LOCATION NEW CROSSING AT HWY. 22  
+ Adelaide Creek

MINISTRY OF TRANSPORTATION AND COMMUNICATIONS ONTARIO	
ADELAIDE CREEK STRUCTURE IN THE VILLAGE OF ADELAIDE	
KING'S HIGHWAY No. 22	DIST. No. 2
CO. OF MIDDLESEX	TWP. OF ADELAIDE LOT II CON. I NER & SER
GENERAL LAYOUT	
APPROVED	CONTRACT No.
DESIGN K.Z.S. CHECK	W.P. No. 92-72-01
DRAWING S.M. CHECK	DATE FEB. 74
DATE FEB. 74	LOADING H520-41
SITE No. 19-191 SHEET 1

FOUNDATION INVESTIGATION REPORT  
For  
Proposed New Crossing  
At Hwy. 22 and Adelaide Creek  
Village of Adelaide, County of Middlesex  
District No. 2 (London)  
W.O. 73-11068 --- W.P. 92-72-01

SUBJECT: Adelaide Creek Structure  
in the Village of Adelaide  
W.P. 92-72-01, Site 19-191  
Hwy. #22, District 2

CONCRETE COLLAR DETAIL  
AT NORMAL CROSS-SECTION  
SCALE: 1/2" = 1'-0"

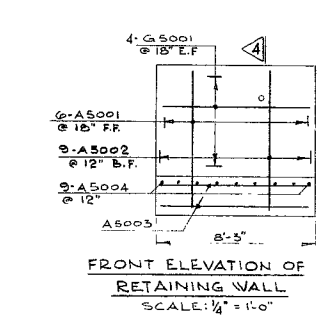
The structure drawings presented at the review meeting June 27, 1974 for the above project indicated that a concrete collar is to be constructed around the pipe at both ends.

This collar precludes the use of the clay seal at the upstream end of the pipe and the filter blanket at the downstream end as recommended in the Foundation Report.

However, the excavation and granular backfill limits for the pipe may be beyond the limits of the collar (also high water level may be above collar). If this is the case, during construction it may become necessary to construct the clay seal and filter blanket beyond the limits of the concrete collar and to above the anticipated high water level ensuring that this treatment is applied to the exposed backfill area at the pipe ends.

The above treatment is not shown on the drawings and therefore your field staff should be made aware of this possible treatment.

We would be prepared to assist you at the time of construction to determine the extent of treatment if any.

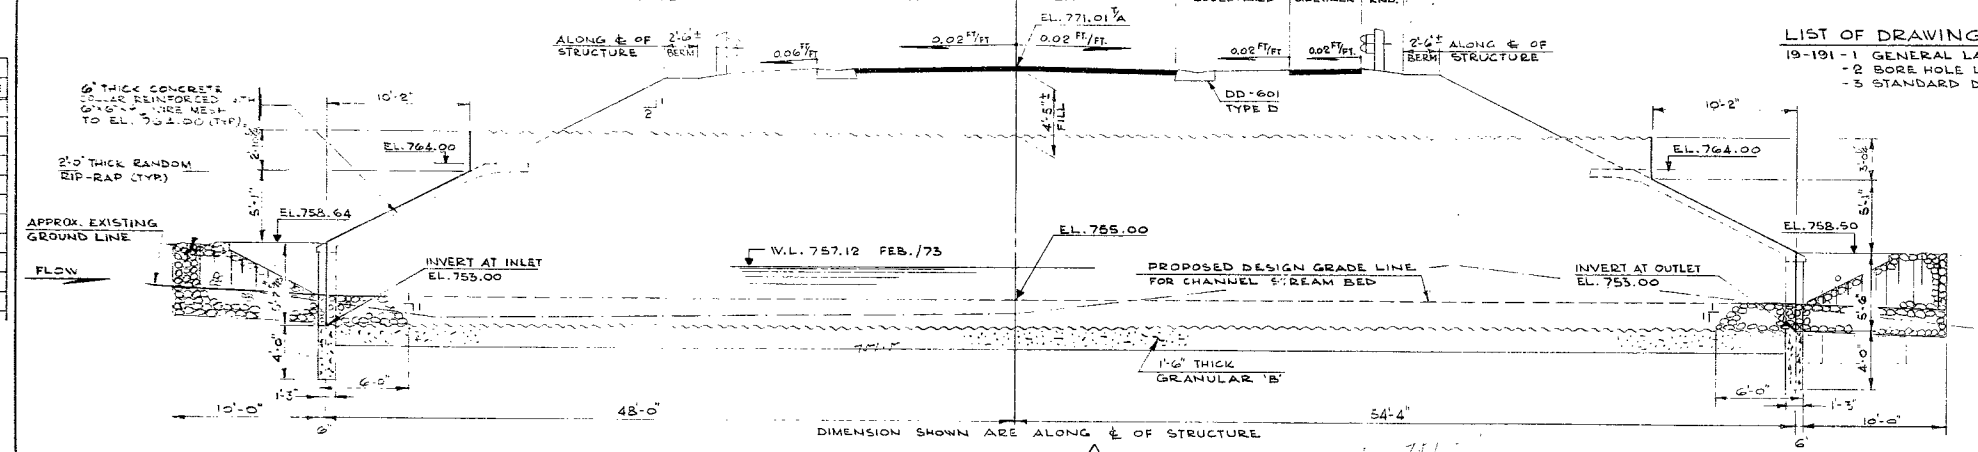
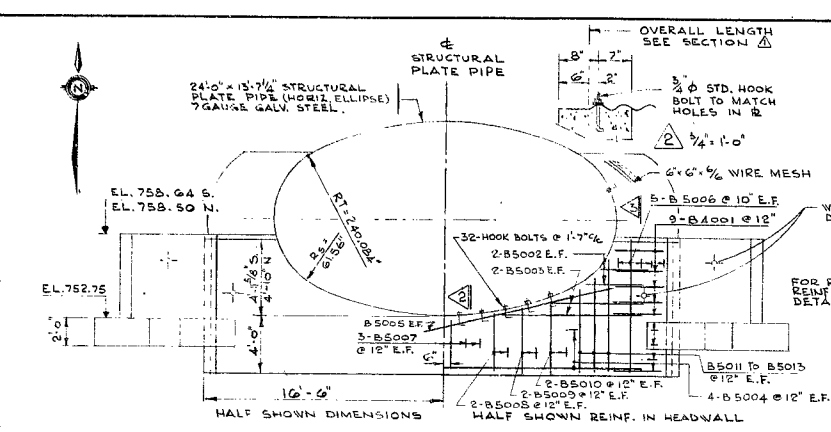
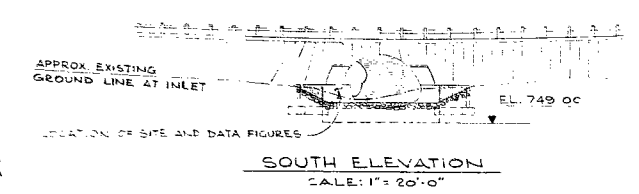
Wing walls & head walls may settle  
excessively due to very loose nature of  
soil at founding elev.
